Product Change Notice - Power tongue jack with enhanced features

Please be advised LCI has changed to a new version of 1817941 Power Tongue Jack, which includes two product enhancements.

Current jack, left, new jack, right.

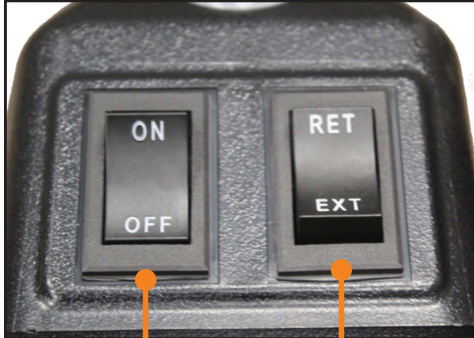
The new jack comes with circuit protection for the LED light card, which prevents damage to the LEDs from high current situations. The new jack also has a rubber boot on the switch to increase water and debris protection and avoid damage to the switch.

There is no change to fit, form function or installation with the new tongue jack. The only visible difference is the boot on the switch. There is also no price change and no part number change.
